Holyrood Park to Ratcliffe  
Terrace, QuietRoute 30

Walk and Cycle  
Improvements

Consultation Report

This report summarises the consultation exercise undertaken during the preliminary design stage of walking and cycling improvements to QuietRoute 30; Holyrood Park Road to Ratcliffe Terrace.

Figure 3 Holyrood Park to Ratcliffe Terrace proposals – Option 1 (3 of 11)

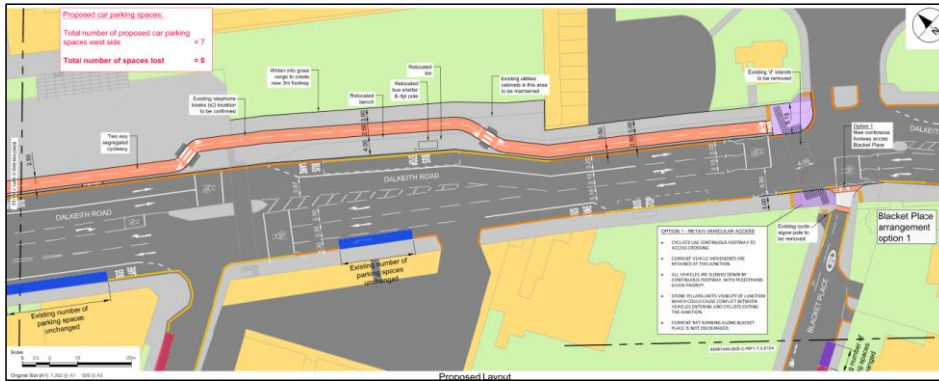
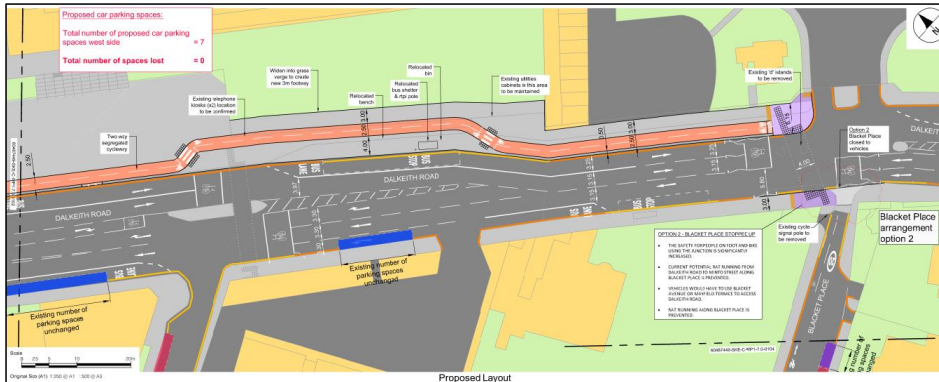
Regarding the design options for the Blacket Place / Dalkeith Road junction, 58.8% of survey respondents preferred design Option 2 (stopping up Blacket Place, preventing vehicular access, and providing a footway across the existing junction) compared to 25.7% who preferred Option 1 (providing a continuous footway across Blacket Place at Dalkeith Road and retaining the existing vehicle movements). The most common response was that Option 2 would be safer and more convenient for pedestrians and / or cyclists. Among those who did not identify as regular cyclists, there was still a majority of support to close Blacket Place. Considering the respondents living within 500m of the route, there was a slightly larger proportion favouring option 2, closing Blacket Place.

Date	Organisation /Type	Comment	Consultation Type	Council Response
				the route, there was a slightly larger proportion favouring option 2, closing Blacket Place. Therefore, on balance, we feel that closing the entry to Blacket Place is a better solution for the safety of cyclists and pedestrians using the scheme and has the majority of support.
2017.05.31	Local Resident	<ul style="list-style-type: none"> <li>Any closure of Blacket Place will result in an opposition campaign.</li> </ul>	External Stakeholder Workshop / Public Exhibition	<p>We note your objection to Option 2, which closes the entrance to Blacket Place. However, this consultation has found a majority of support for closing the street, including amongst those who don't regularly cycle. Considering the respondents living within 500m of the route, there was a slightly larger proportion favouring option 2, closing Blacket Place.</p> <p>Therefore, on balance, we feel that closing the entry to Blacket Place is a better solution for the safety of cyclists and pedestrians using the scheme and has the majority of support.</p>
